Product Change Notice

Issue Date: 26-November-2021

New replacement die for the part numbers listed below.

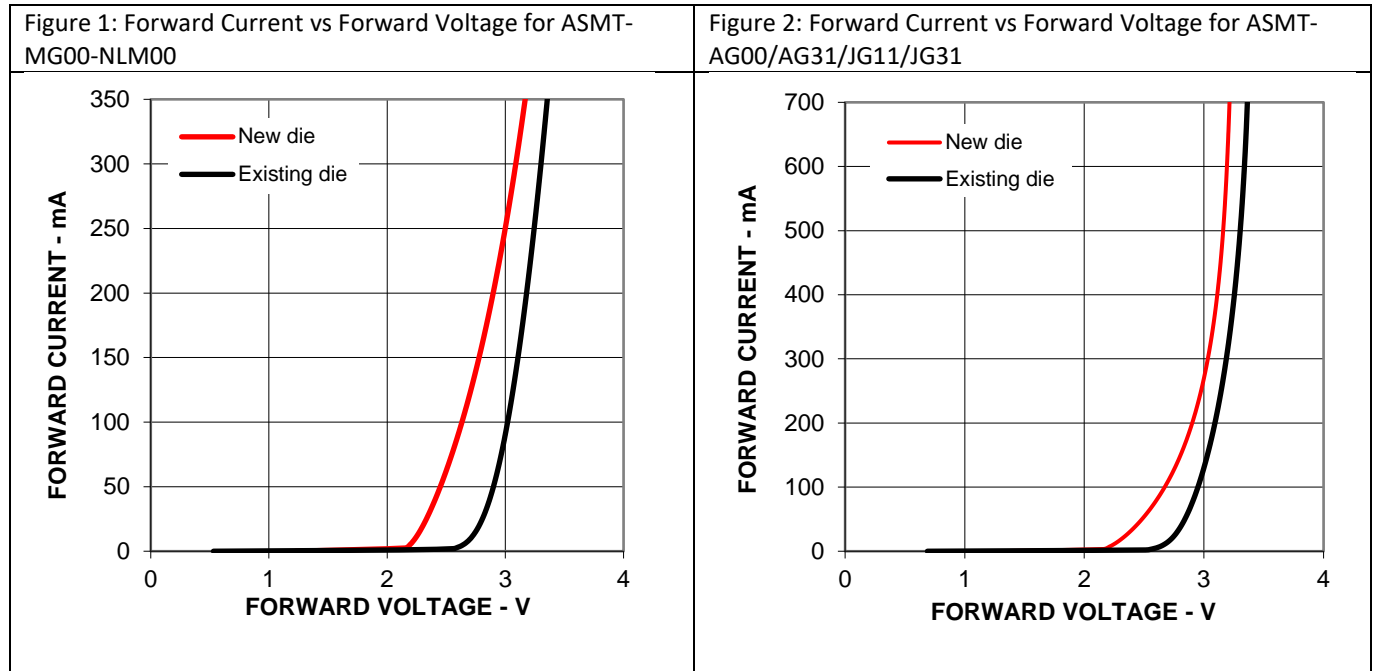
Description and Extent of Change:

The new die will replace the existing die for all affected part numbers.

There is no change in the product fit and form. The product with new die has slight different in forward voltage characteristic as shown in the graphs below.
